REDEVELOPMENT AGENCY OF CENTERVILLE CITY AGENDA

CENTERVILLE RDA BOARD

Short Title: Review – "Island" Parcel (Iggy's)

**STAFF REPORT
AGENDA: ITEM 2**

SOUTHWEST elevation
1/10

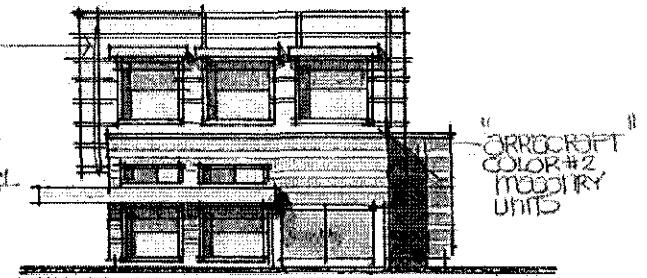
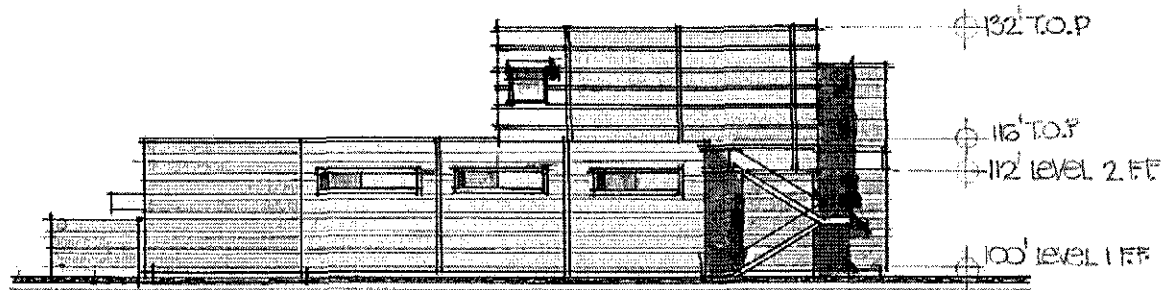
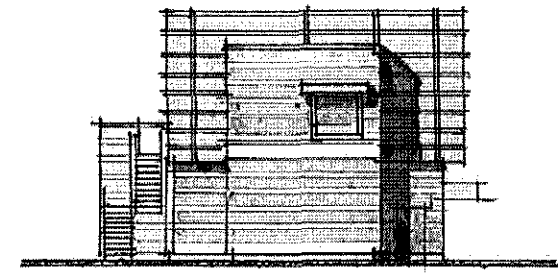
All signage require a separate permit and must be reviewed by staff for approval at the time a sign permit application has been submitted following Section 12-54 of the Zoning Ordinance. It appears the applicant is proposing wall signage only on the north and south walls. Yet, if the applicant desires more signage, this must be depicted on the final elevation plans.

- Staff Response: Elevations were submitted, yet according to Section 12-63-040(c)(1), a storyboard is required as part of review for the final site plan approval. As mentioned previously the building has a very unique architectural design. The use of glass, panelized rain screen (outer aluminum wall

panels), steel and brick are the main materials on the building. Although the applicant has submitted plans indicating a conceptual color, the applicant will need to indicate the actual colors on the color board provided at the time of Final Site Plan Application submittal. The colors appear to be earth tone in shades of green, tan, orange and grey. Staff believes the architecture is a perfect blend of the surrounding area, yet adds a new modern element to the Parrish Lane corridor. Many of the elements and neo modern style is currently already found along Parrish Lane with the metal panels of Dairy Queen, the long lines and rectangular design of the Legacy apartments and although under a differing approval process, the newly remodeled Wendy's and the Existing MTC Building also have similar elements to the proposed building. The structure has no stucco, yet uses brick to tie in to the island parcel and Iggy's. Staff believes that since this is a retail store and not a restaurant, it should have a unique design, yet still meet the intent of the Parrish Lane Guidelines. It appears the applicant has met the upgrade requirements for a primary facade of 25%, the secondary wall at 15%, and all other walls at 5%. Yet in order to emphasize the architecture, again it is requested that outdoor lighting be placed on the building.

15. All proposed signage shall be depicted on the final elevation drawings.
 16. A storyboard shall be submitted with the final site plan application depicting all colors and materials to be used on the proposed building.
